Description of Revisions: *This bulletin replaces the version dated February 2011. A new figure is added to clarify the components of the slip clamp assembly.*

EPA07 Exhaust Bellows Replacement Parts			
Description	Original Part Number	Replacement Part Number	New Clamp Assembly Part Number
5-Inch Bellows	A04-25022-018	04-28522-000	TCX AMS015AM (2 ea) or TCX AMS015 (2 ea)
4-Inch Bellows	A04-25922-018	04-28578-000	TCX AMS014AM (2 ea) or TCX AMS014 (2 ea)
	A04-26193-018		
Turbo Outlet Pipe Support Bracket	04-24627-000	04-29024-000	—

Fig. 1, Slip Clamp Assembly

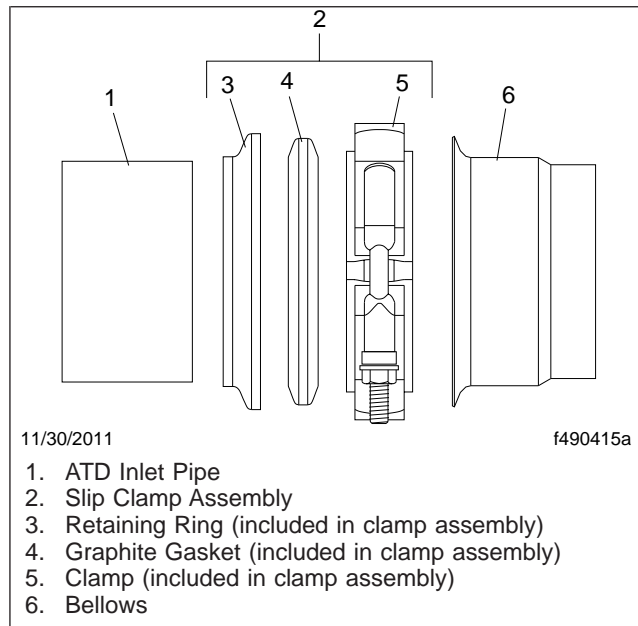
If you have a failed exhaust bellows on an EPA07 engine installation, replace it with a new style bellows, and two new matching clamps. Also, if vehicle currently has the early style turbo outlet pipe support bracket (p/n 04-24627-000) installed, replace it with a revised part (p/n 04-29024-000) that provides better support and reduces vibration. Refer to **Table 1** for the original and replacement part numbers. Refer to **Fig. 1** for the clamp assembly configuration.
